To: Glenn Girven
Clerk Township of Havelock Belmont Methuen

Submission #2 to Council of Havelock Belmont Methuen by Ambrose Moran
Re Proposed Zoning Bylaw Amendment (**Public Mtg April 14 2009**)

Septic Setbacks

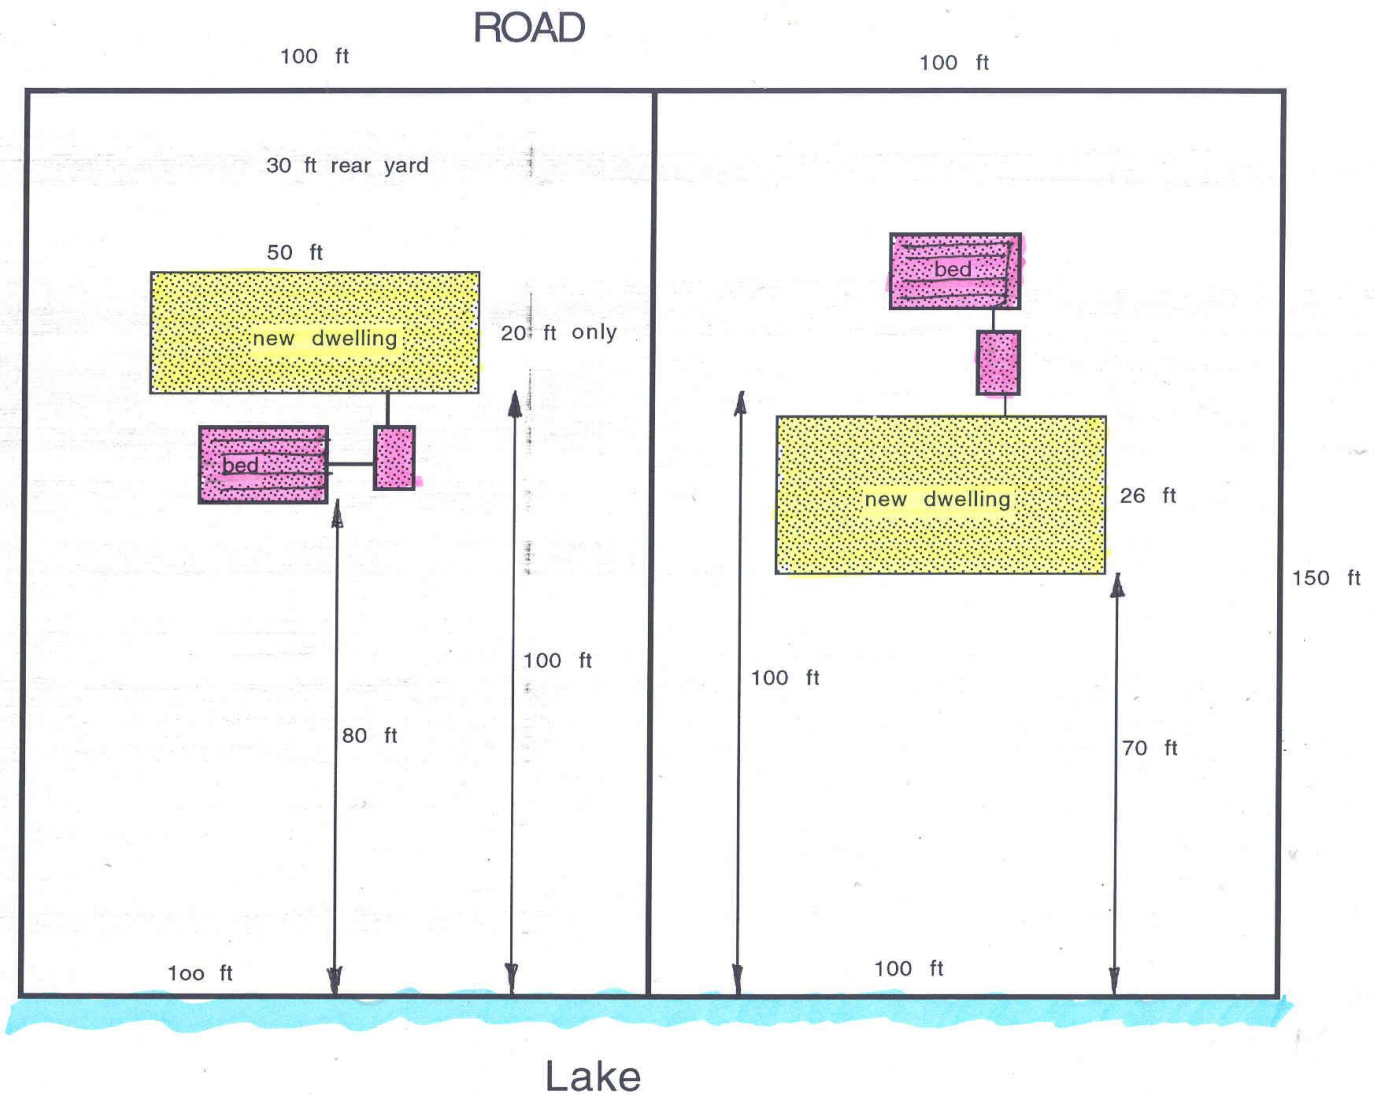
County of Peterborough OPA #3 applicable to the part of Jack Lake in North Kawartha Township is intended to encourage septic fields to meet the 30 meter setback **but allows discretion to the Peterborough County Health Unit to continue to approve septic with 50 ft setbacks².**

The concept of setting new development back 30 meters from lakes to protect water quality is not achieved in this approach. (Reference dwg attached)
